# PacifiCorp - Stakeholder Feedback Form

## 2021 Integrated Resource Plan

Renewables load correlation, Supply Side Resources, Coal

Please note the following cost projections from the [2019 NREL Oregon Offshore Wind Site Feasibility and Cost Study](#), and the [2019 Offshore Wind Technology Data Update](#):

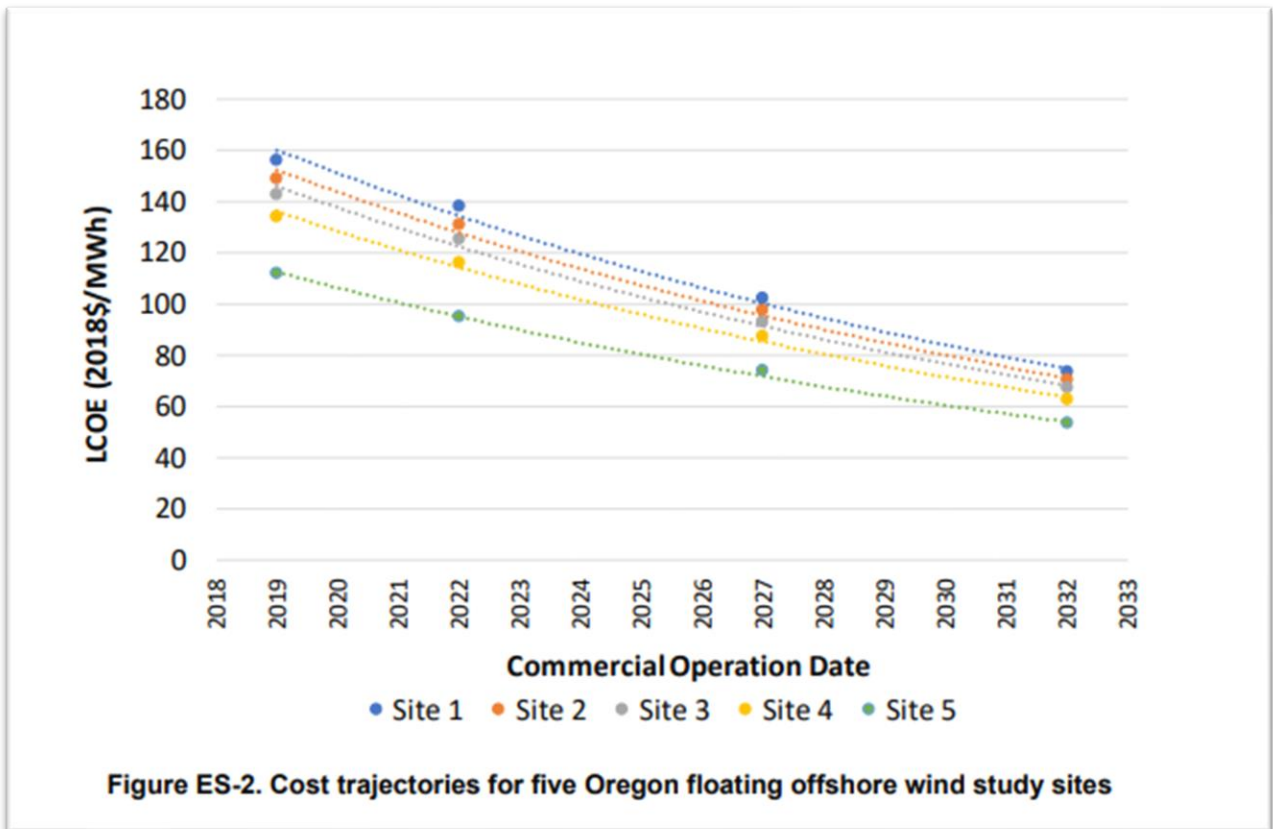
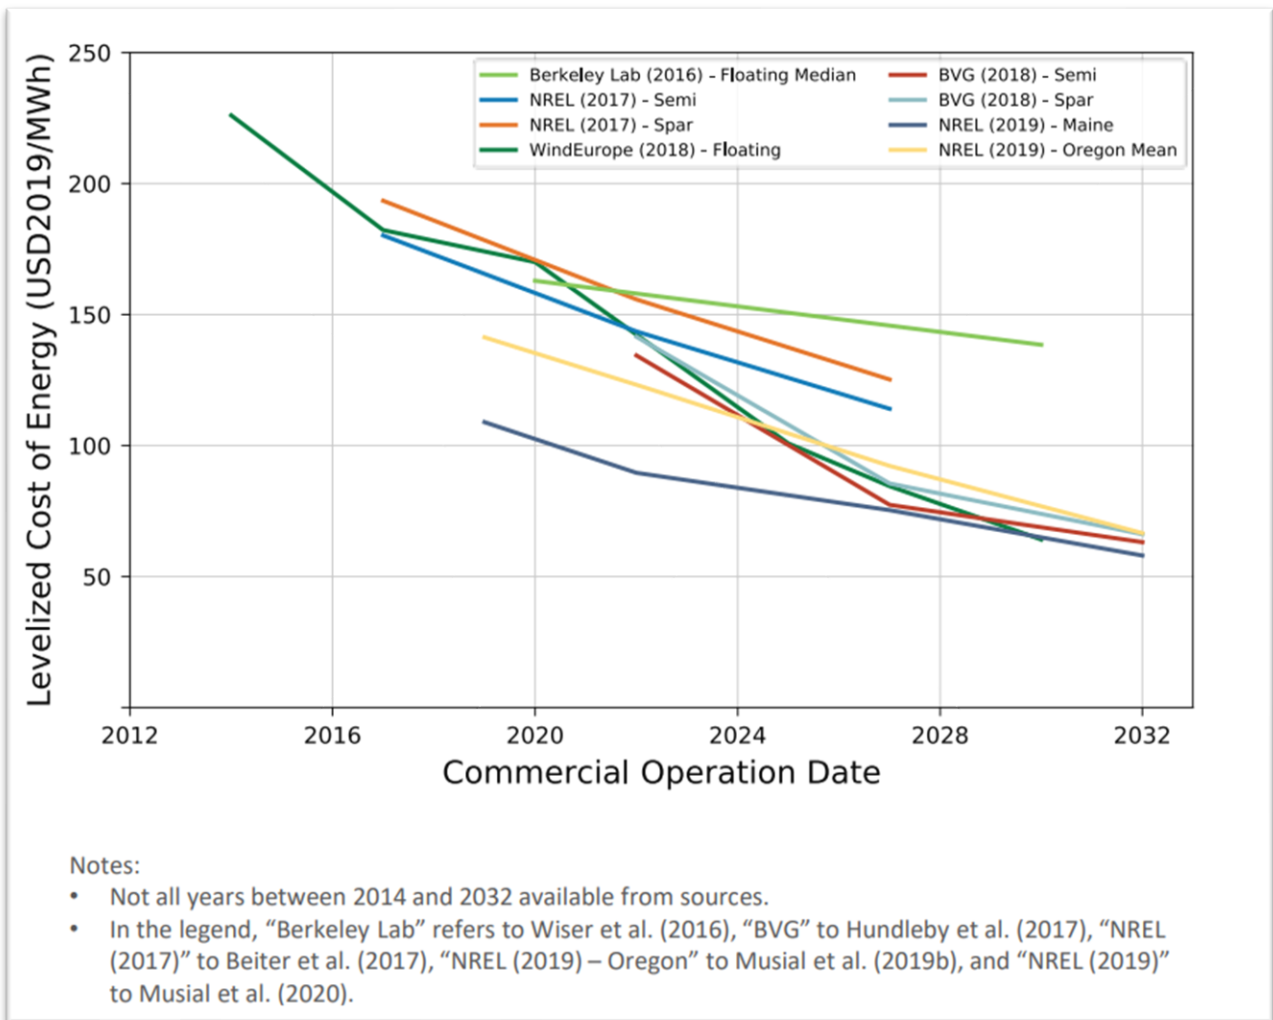
7. There is expected to be significant activity in offshore wind leasing through the Bureau of Ocean Energy Management (BOEM) in the near term, and the White House has issued an [executive order](#) with the goal of identifying steps toward doubling offshore wind production by 2030.
  - a. Would it be possible for PacifiCorp to include a sensitivity in the 2021 IRP that shows the economics of a 500 MW offshore wind installation off the coast of Oregon within five to ten years, using the best cost estimates available today?

- b. Would PacifiCorp please include in the 2021 IRP a discussion of the potential for offshore wind off the West coast, including the Oregon coast? This would include a discussion of potential benefits from increased reliability in the west and any avoided transmission construction costs. Additionally, Staff would appreciate a clear description of the specific information PacifiCorp would need to have access to in order to include offshore wind in a future IRP supply side resource table.

PacifiCorp plans to include a discussion of the potential for offshore wind along the West coast of the continental United States, including Oregon, in the 2021 IRP and will consider including an offshore wind option in the supply-side resource table for the 2023 IRP. Offshore wind holds the promise of high capacity factors, but at significant cost; the National Renewable Energy Laboratory’s 2019 Offshore Wind Technology Data Update estimates the levelized cost of energy for offshore wind at \$100 per MWh in 2019 and decreasing to between \$50 and \$75 per MWh by 2030. It should also be noted that most of the offshore wind development occurring along the shores of the United States plans to use fixed bottom wind turbines installed in water less than 60 meters deep. The water depth off the Oregon coast will likely require floating wind turbines and there were only 84 MW of floating wind turbines installed worldwide at year-end 2019. PacifiCorp prefers to use cost and performance data of operational utility scale generation assets to inform its supply-side resource table, but it will continue to review the best information available for offshore wind as it prepares for the 2023 IRP.
